Product Change Notification

Change Notification #: 116086 - 00
Change Title: Intel® Server Chassis H2216XXKR2,
Intel® Server Chassis H2312XXKR2,
Intel® Server Chassis H2224XXKR2,
PCN 116086-00, Product Design, Label,
Update BIS Regulatory Mark and update
firmware of the PSU
Date of Publication: February 13, 2018

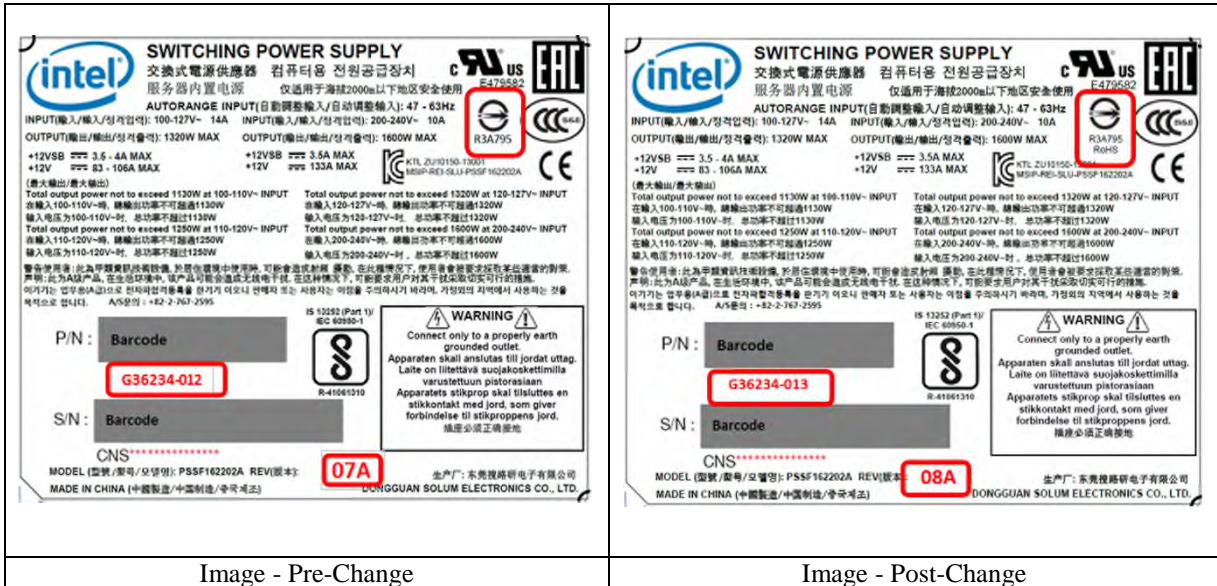
1. Update the power supply unit label (see picture below)
 - Update the India BIS mark regulatory label.
 - Roll up the product number from G36234-012 to G36234-013.
 - Change revision from 07A to 08A.
